ELEMENTARY DIAGRAM
 SAFETY INJECTION-SHUTDOWN CLG SYSTEM
 SHUTDOWN CLG TEMP CONTROL VALVES
 J-SIA-HV-657 & J-SIB-HV-658

BECHTEL
 LOS ANGELES
ARIZONA NUCLEAR POWER PROJECT
PALO VERDE NUCLEAR
GENERATING STATION

BECHTEL PALO VERDE NUCLEAR GENERATING STATION UNITS 1, 2 & 3
DRAWING CHANGE NOTICE (DCN)
JOB NO. 10407

DRAWING NO.	SHEET NO.	REV.	DCN NO.
13-E-SIB-027		3	3

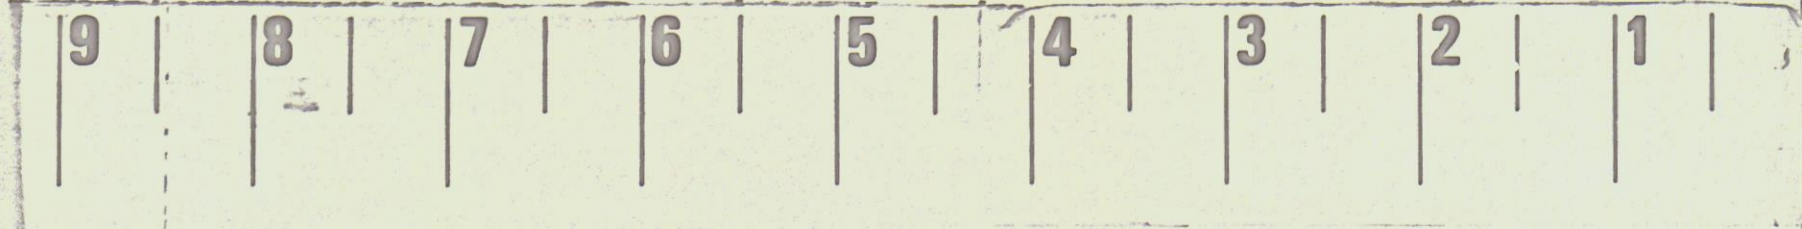
DESCRIPTION OF CHANGE
① IN THE SAFETY EQUIPMENT INOPERABLE STATUS CIRCUIT,
CHANGE:
FROM → TO

② ADD

AFFECTED EQUIP: MCC'S E-PHA-M3310 & E-PHB-M3412 (12-118)
